Planning Commission Staff Report

Petition: **P.Z. 13-2022 17955, 17965, 17985, and 17995 N. Outer 40 Rd. (Gateway Studios, LLC)**: A request for a zoning map amendment from the “M3” Planned Industrial District to “PC” Planned Commercial District for 77.8 acres located on the north side of Outer 40 Road (17W640035, 16W320011, 16W330021, and 16W320022).

RE: **PZ 13-2022 (Gateway Studios)** – Response Letter to Comments Raised at January 23, 2023
Public Hearing (Stock Project No. 222-7282)

RE: **PZ 13-2022 (Gateway Studios)** – Response Letter to Comments Raised at January 23, 2023
Public Hearing (Stock Project No. 222-7282)

Figure 4: Preliminary Development Plan

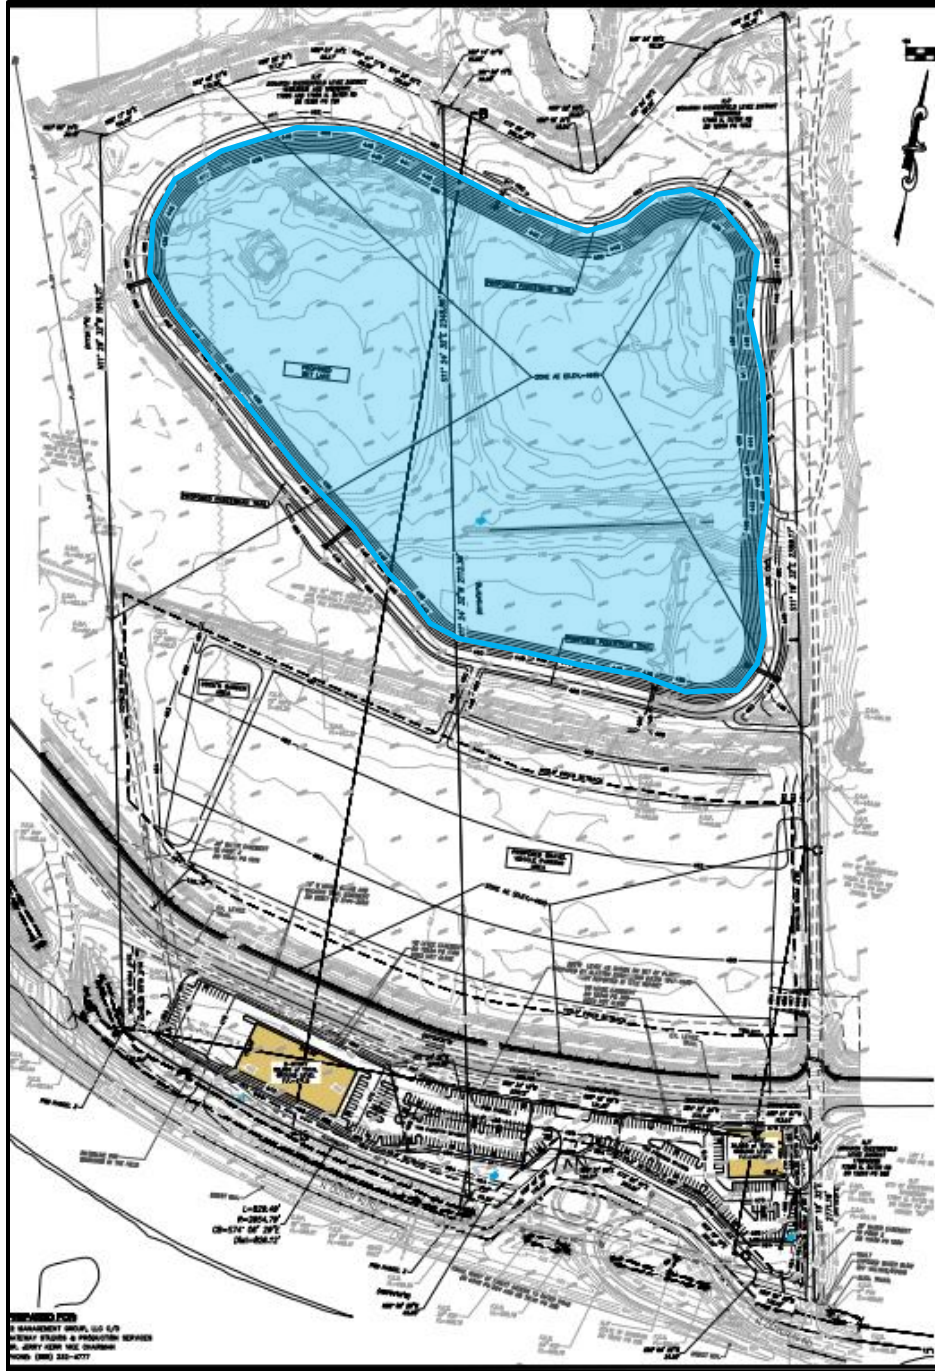
Concern was raised regarding the size and material of the proposed gravel parking area to be located north of the levee trail including the amount of dust that may be generated from the gravel lot. Additionally, the City of Chesterfield Comprehensive Plan designates this area as "Conservation" and indicates properties within this designation should, "Limit impervious surface or encourage the use of stormwater BMPs." Provide information on how the development team will be addressing the above concern and consistency with Conservation land use designation.

3. Provide the parking setbacks located to the north of the Levee Trail.

4. Show all the setback lines on the Preliminary Development Plan.

5. Indicate boundaries of SFHA, Floodway and SPA on the Preliminary Plan.

Response: We understand the Comprehensive Plan Designation. It is our understanding that the Planning Commission discussed in 2022. This property and the general consensus was, "Development" as Regional Commercial Designation would be appropriate.

The gravel lot is being placed at elevation 451-453.50, the Trail on Top of Levee is elevation 477.00 (23.50-25.50 Higher) and is approximately 120-155 feet north of the trail. The proposed Lake will replace Borrow Pits, the addition of a Trail, and Cook's Garden are all consistent with conservation and passive recreation. The use of gravel is the only material that is manageable and sustainable within the 100-year floodplain. Similar to another approved project within the valley, the application of Calcium Chloride was approved by the Planning Commission as a Dust Control Product. This product if Environmentally Sensitive may be used on this project or an equal product that is environmentally sensitive applications. The maximum size of the overflow lot has been modified (made smaller) to accommodate the location of the Cook's garden at the West end of the lot.

Response: Added to Plan.

Response: Added to plan.

Response: Added to plan.

SHEET TITLE:
WB-67 EXHIBIT

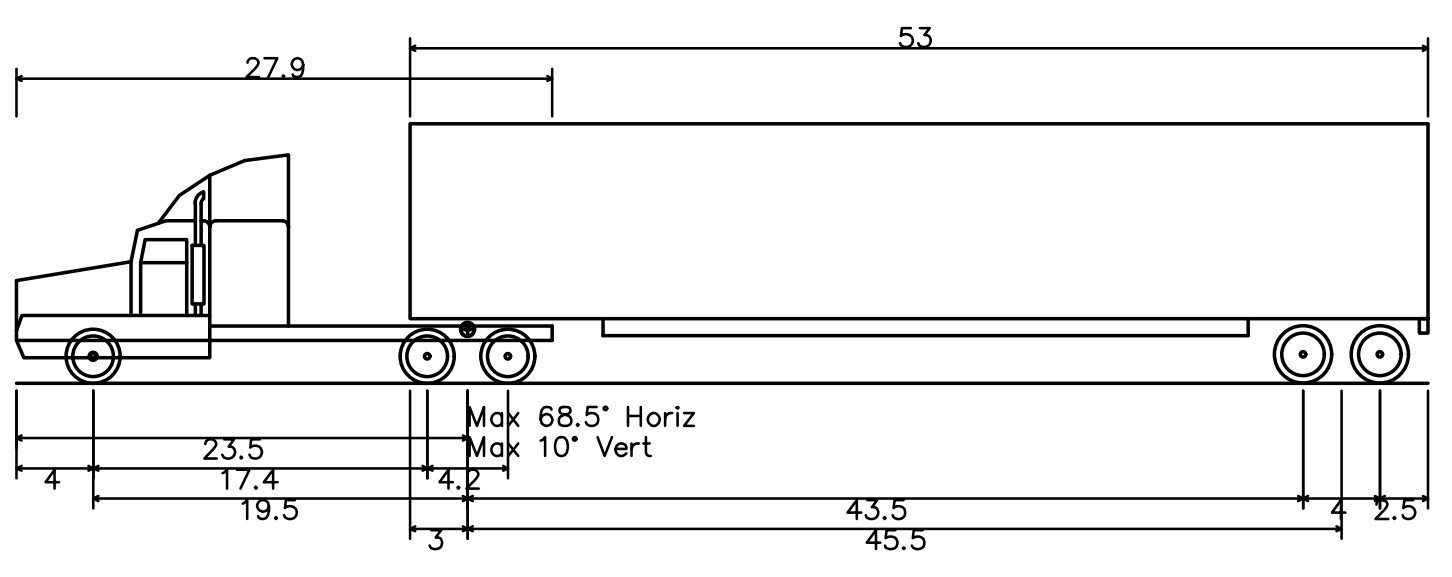
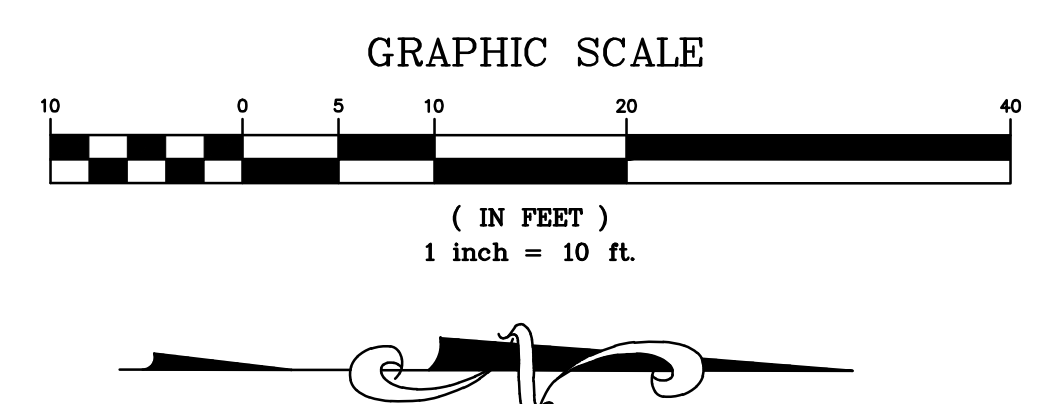
6. Based on information provided it is understood that large vehicles will utilize the parking area north of the levee. Confirm that these vehicles can cross the levee and levee trail without being high centered. Additionally, provide information on the frequency and volume of vehicles that are anticipated to cross the levee and suitability of the existing improvements based on the site, weight, and volume of vehicles crossing at this location.

Response: Attached is an exhibit of a WB-67 Vehicle Driving over the levee, it clears by 0.95 feet. The frequency is not known at this time, but as indicated at the Public Hearing it's primary use is for special events. All necessary materials and soil testing of Access Road will be performed and considered at the time of a Site Development Section Plan and Site Improvement Plans associated with approval of the Gravel Overflow Lot.
